PLANT NAME: Monticello

ENCLOSURES:
Response to AEC Questions on Monticello
High Energy Line Breaks Outside of Contain-
ment

RESPONSES TO AEC

QUESTIONS ON MONTICELLO HIGH ENERGY

a. Jet Impingement

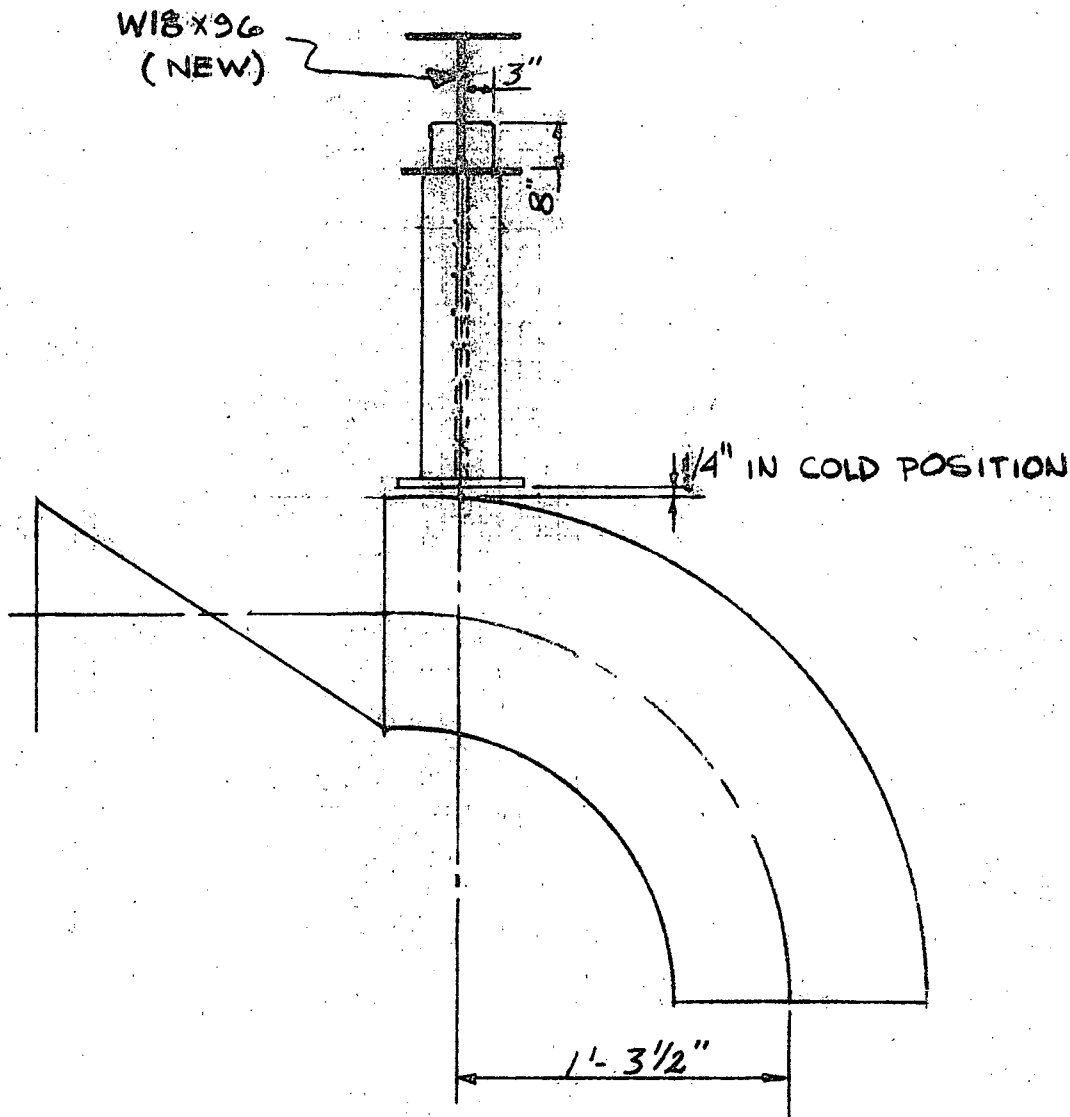
3. QUESTION: Submit details of the additional protection mentioned in paragraph 6.2.2(1).

ANSWER: The additional protection envisioned at the time of the report was a plate protecting the turbine building mezzanine floor (elevation 931'0") from a jet of water impinging on the floor. This would also have provided pipe whip protection. Further analysis of the break and break locations resulted in the following:

The original calculations assumed that the maximum operating pressure of the pump continued for a long period of time. This was a conservative approach that did not take into account the effects of pump discharge head versus the flow characteristics (system resistance). If we take into account these effects (pump run-out), the forces due to jet impingement will be reduced by approximately one order of magnitude. Using these new forces and the same method of calculation described in paragraph 5.1 of the report, the mezzanine floor will withstand the jet impingement, thereby supporting the redundant safeguard MCC without adding any steel plate.
